MPLAB® PICkit 4 VPP Overshoot Modification

Solution:
To avoid the need of the RCR network and its effects, assembly #10-10094R1, PCB #04-10441 REV 3 requires slew rate control of the VPP load switch to smooth out fast edges which may cause overshoot under certain conditions.

Figure 1

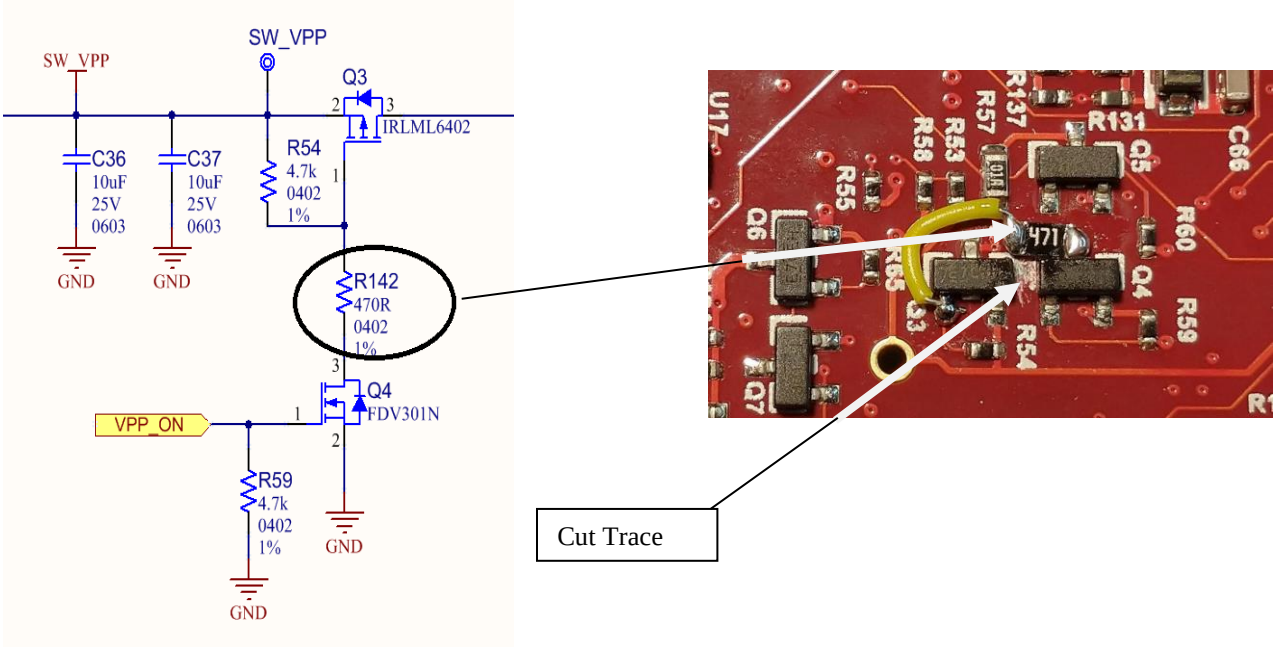
Symptom: During programming of some PIC devices that use High Voltage VPP latch-up can occur and the device can consume more current than is typically required.

The latch-up is due to the device experiencing voltage overshoot conditions on the VPP pin as the device data sheet indicates. The overshoot signature will vary depending on device, voltage, package, cable inductance, or any other capacitance and resistor loading on the VPP pin.

Problem:
Some PIC16/18 devices have options to use high voltage on VPP or NMCLR to program the device. On some devices, the VPP/NMCLR pin has special ESD protection. Overshoot on the pin can result in a reset condition or current consumption outside of the specification. To avoid this situation, the data sheets for these devices recommend the use of an RCR network with a pull-up, a power up charge capacitor and a series resistor configuration into VPP. A series resistor of 470 ohms is used to dampen any overshoot and to limit current into VPP/NMCLR.

The schematic and rework for this change is shown in the figures below.
R142 is added between the gate of Q3 or pin 1, and the drain of Q4 or pin 3.
R142 can be soldered directly to the drain of Q4. However, the gate of Q3 must be isolated by cutting the existing trace running between both components as indicated below. A wire can connect the gate of Q3 with the end of the R142 resistor.
